TO: T10 Membership
FROM: Paul A. Suhler, Quantum Corporation
DATE: 9 July 2008
SUBJECT: T10/07-469r6, ADT-2: Internet ADT (iADT)

Changes to ADT-2 rev. 5

Figure 4 – ADT communication model

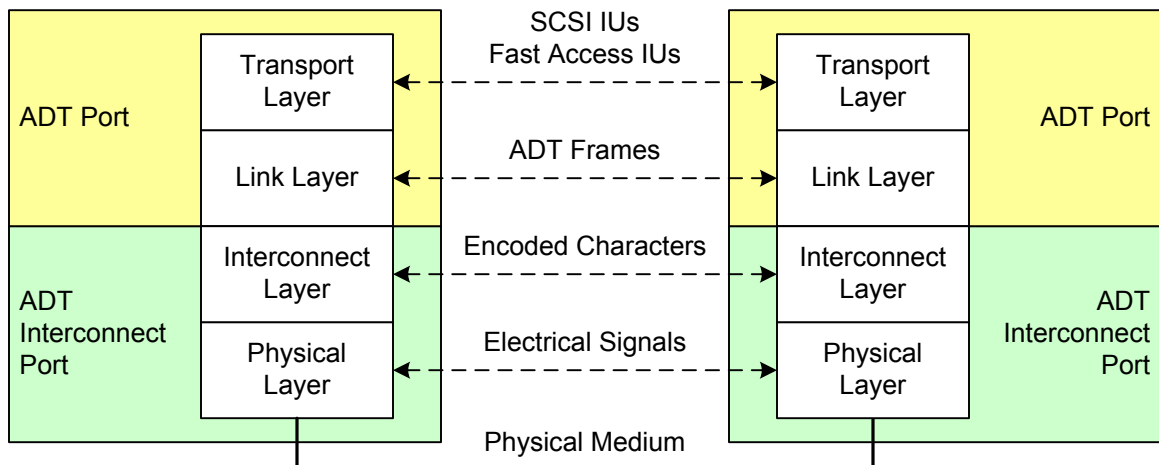
Figure 4 shows the communication between ADT ports and between ADT interconnect ports at the different layers of the protocol, from the physical layer to the transport layer. At the transport layer, information units (IUs) are passed between ADT ports. At the link layer, ADT frames are passed between ADT ports. At the interconnect layer, encoded characters are passed between ADT interconnect ports. At the physical layer, electrical signals are passed between ADT interconnect ports. The physical layers are connected by the physical medium.

Figure 6 – ADT serial port example

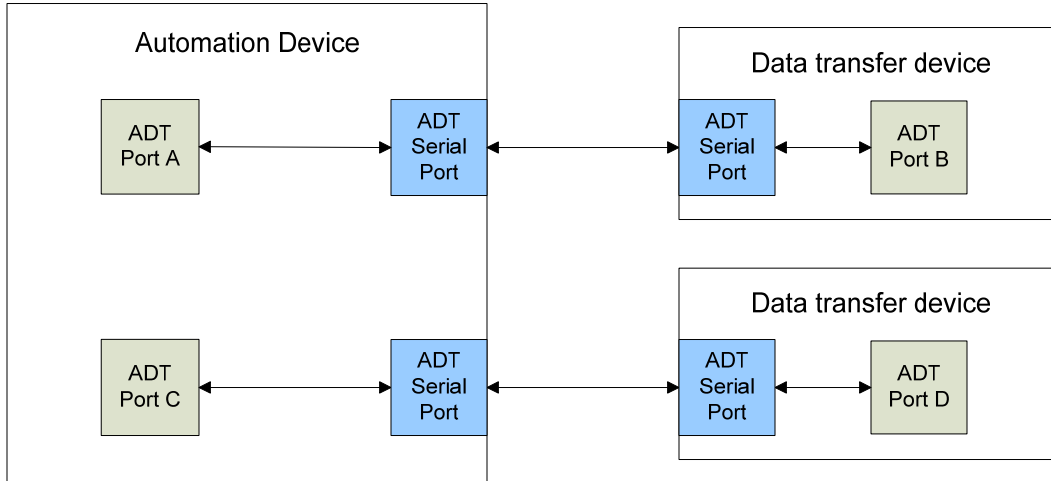
The term ADT serial port refers to an ADT interconnect port using the ADT serial transmit-receive connections (see 5.2.5.2) and the ADT serial interconnect layer (see 6.3). A single ADT port may use an ADT serial port for connection with another device. Figure 6 shows connections corresponding to Figure 3. ADT port A is connected with ADT port B, and ADT port C is connected with ADT port D.

Figure 7 – ADT TCP port example

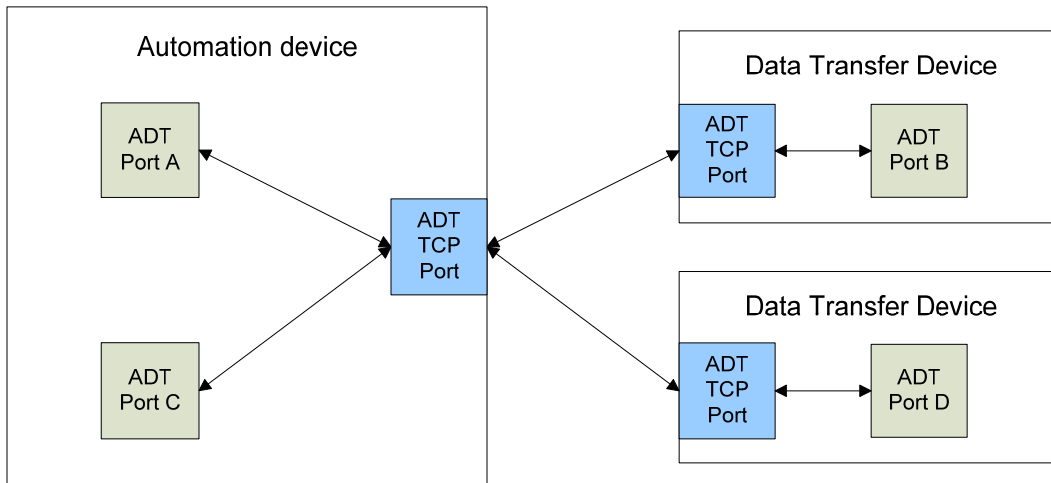
The term ADT TCP port refers to an interconnect port using the ADT Ethernet transmit-receive connections (see 5.2.5.3) and the ADT TCP interconnect layer (see 6.4). Multiple ADT ports in one device may share a single ADT TCP port for connection to other devices. Figure 7 shows two pairs of ADT ports connected by ADT TCP ports, corresponding to the connections shown in Figure 3. ADT port A is connected to ADT port B, and ADT port C is connected to ADT port D.

Figure 16 – Protocol services for establishing a connection

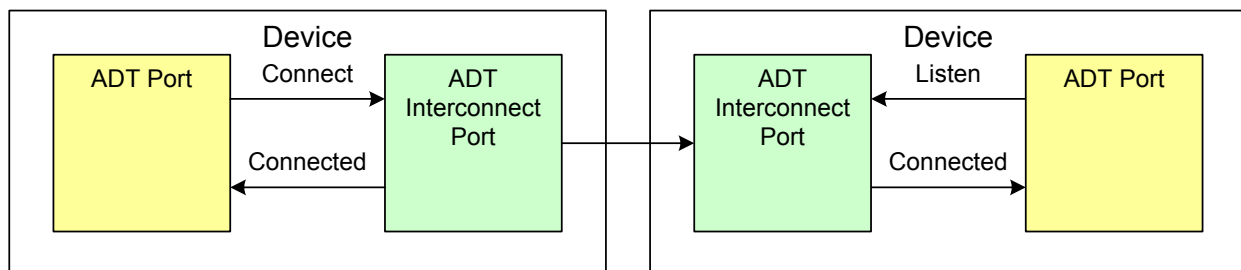
An ADT port may either initiate a connection to a specific interconnect port, or await a connection from any interconnect port. An ADT port initiates a connection by invoking the **Connect** service request. An ADT port awaits a connection by invoking the **Listen** service request. When the connection is established, both ADT ports receive a **Connected** service indication. Figure 16 shows the relationships among the protocol services used to establish a connection.

Figure 17 – Protocol services for transferring data

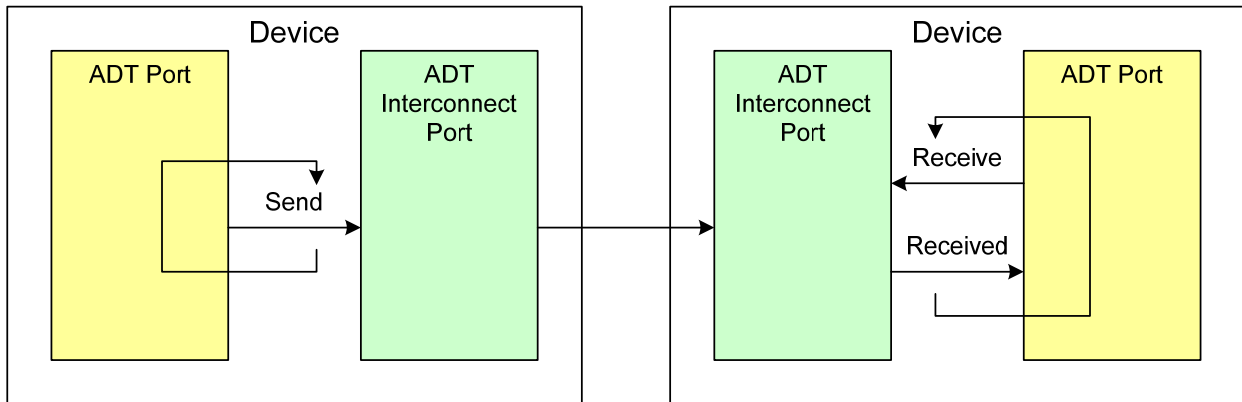
Figure 17 shows the relationships among the protocol services used to transfer data.

Figure 18 – Protocol services for closing a connection

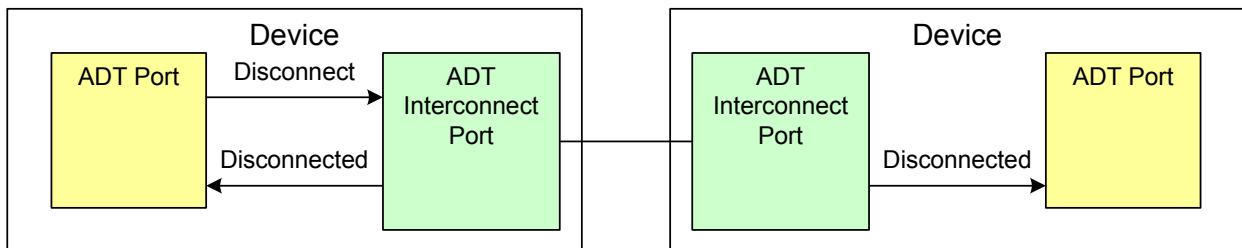
An ADT port closes a connection by invoking the **Disconnect** service request. Any characters that have been submitted for delivery by earlier **Send** service requests will be transmitted before the connection is closed. When an ADT port receives a **Disconnected** service indication, the connection is closed and no more characters shall be received. Figure 18 shows the relationships among the protocol services used to close a connection.

Figure 19 - Protocol services for performing a reset

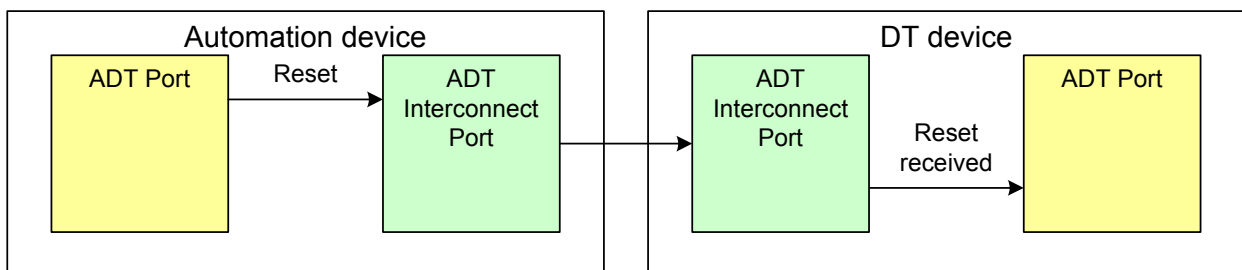
An ADT port in an automation device resets an ADT port in a DT device by invoking the **Reset** service request. This causes the ADT port in the DT device to receive a **Reset received** service indication. Figure 19 shows the relationships among the protocol services used to perform a reset.
